Meeting Summary

29 Road Interchange at I-70, NEPA/1601 Project

Meeting Name: TAC Meeting #16

AM Peak Hour V/C Ratios

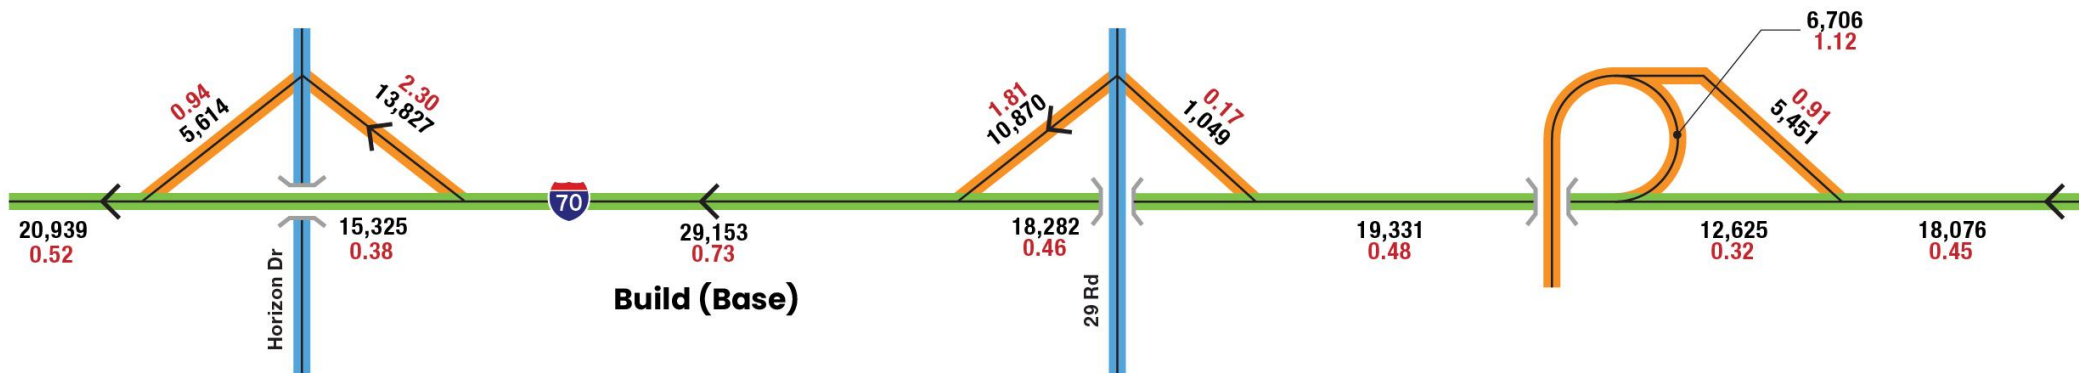
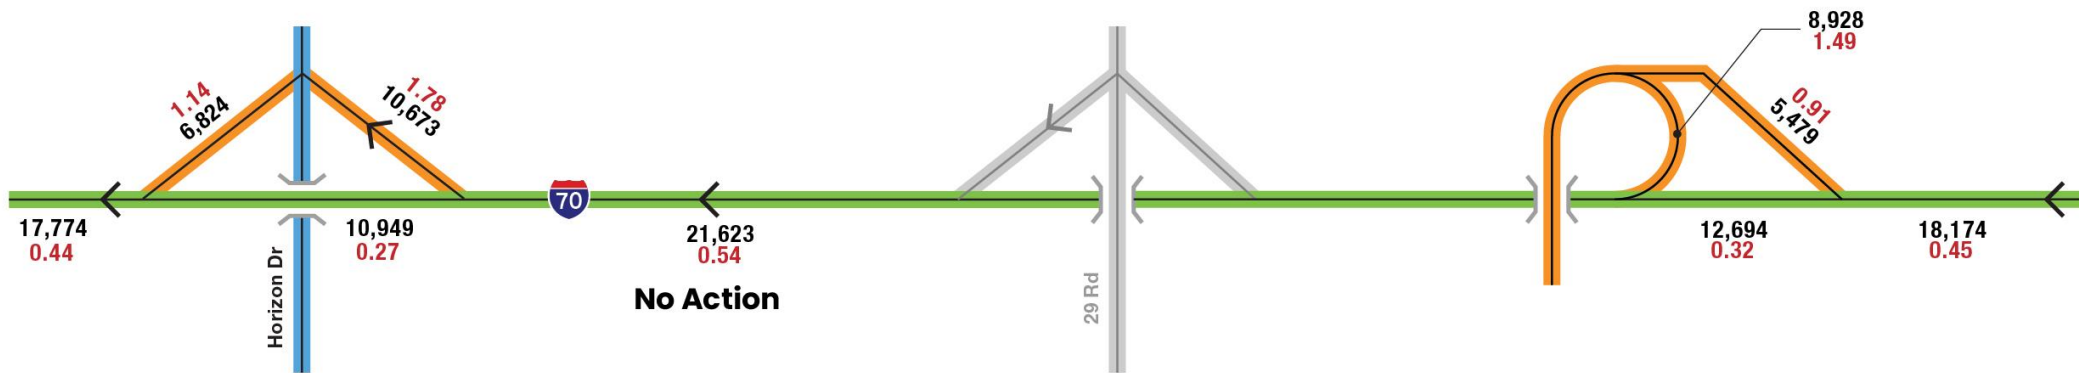
Question: What is a normal number and why is 2.88 alarming?

Response: These are the volume over capacity ratios. In other words, V/C is the volume of projected vehicles divided by the capacity of the roadway segment which essentially means that there are more vehicles on the roadway than can effectively be handled. As that number approaches 3, that is saying it is 2.8 times over capacity.
